EU Commission proposal for the Delegated Regulation supplementing Regulation 2023/1542 for Art. 7 of the Battery Regulation regarding “establishing the methodology for the calculation and verification of the carbon footprint of electric vehicle batteries”

Volkswagen Group Position

2.2. System boundary and cut-off rules:

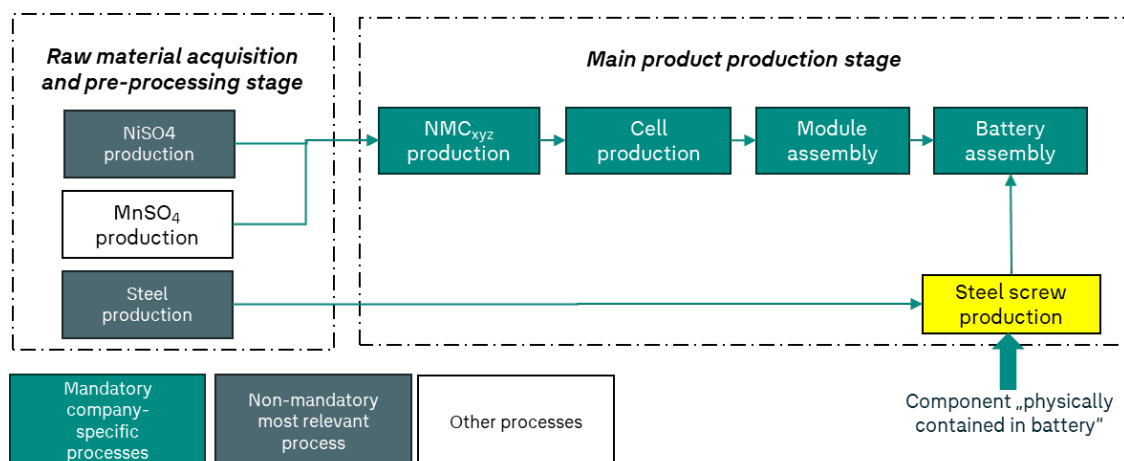
- The scope of the manufacturing stage is unclear when it comes to defining what classifies as company-specific processes:
 - Section 2.2.1 (a), raw material acquisition and pre-processing, refers to several specific components (e.g. precursors, cooling pipes, fluids for thermal condition system).
 - Other small components that qualify as “physically contained in or permanently attached to the battery housing” and not part of the activities as highlighted in Section 2.2.1 (b), Main product production, could therefore be regarded as part of the main product production stage.
 - Example for a steel screw is presented below. How to model such a component and its transportation?

- The definition of “physically contained in or permanently attached to the battery housing” is not clear, e.g. the physical boundaries of a thermal conditioning system are not straight forward.

- Provide a clear and precise definition of the activities covered in the “main product production stage”. This should only include the activities as currently listed in Section 2.2.1 (b), Main product production.
- All other components, e.g. steel screw or circuit boards, should fall under the “raw material acquisition and pre-processing” stage. This should be made more explicit under Section 2.2.1 (a), raw material acquisition and pre-processing, whereby currently only a reference is made to the following components: cathode active material precursors, anode active material precursors, solvents for the electrolyte salt, the pipes and the fluid for the thermal conditioning system.
- Provide further clarification on what is meant with “physically contained in or permanently attached”.

Figure 1. Overview EF Dataset age

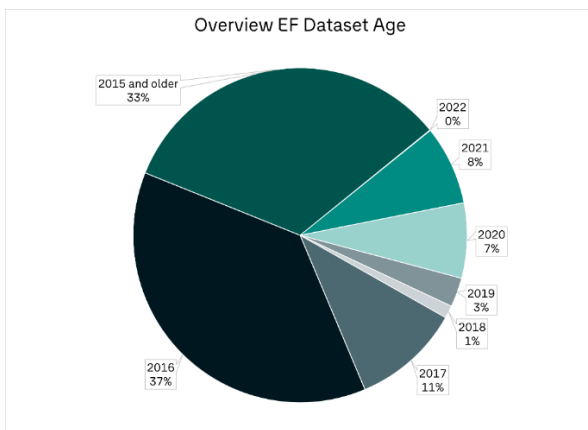
- Generally, the majority of EF datasets can be considered as outdated since 70% of them have not been updated for > 8 years:

- For a timely implementation of Art. 7, it is essential that the Carbon Footprint Datastock is available soon and free of charge. A specific publication date is needed to allow for timely planning.
- The Carbon Footprint Datastock and other LCDN should meet at least the following requirements:
 - They must contain all data sets necessary for battery LCAs.
 - The data sets must be able to map different production routes and geographies.
 - The database must be updated regularly since LCA calculations should not be based on outdated information e.g., electricity mixes.
- In addition to technological representativeness, temporal and geographical representativeness should also be taken into consideration for selecting the data set. This approach prevents the use of a low-quality data set from the official data stock when a more suitable data set is available from another source.

Figure 2. Overview Regionality of EF Datasets

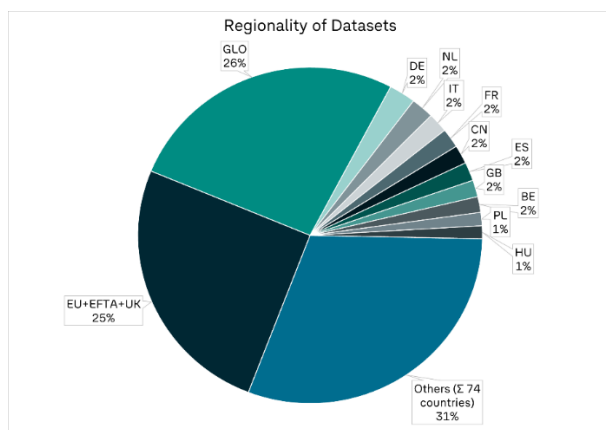
- It is not yet clear when the Carbon Footprint Datastock will be available on the LCDN
- Currently technological representativeness is used as the only criterion to select secondary datasets. This does not ensure data quality sufficiently.
- Generally, technological representativeness is difficult to assess for parties that are not the process owner. The level of detail that describes the technology behind the datasets varies but is usually high (e.g., specific process temperatures and chemical concentrations are mentioned). This can easily lead to misjudgments within technological representativeness.
- Current datasets available from LCDN are insufficiently representative in terms of technology, geography and time. e.g., electricity grid mix Germany (1-60kv):
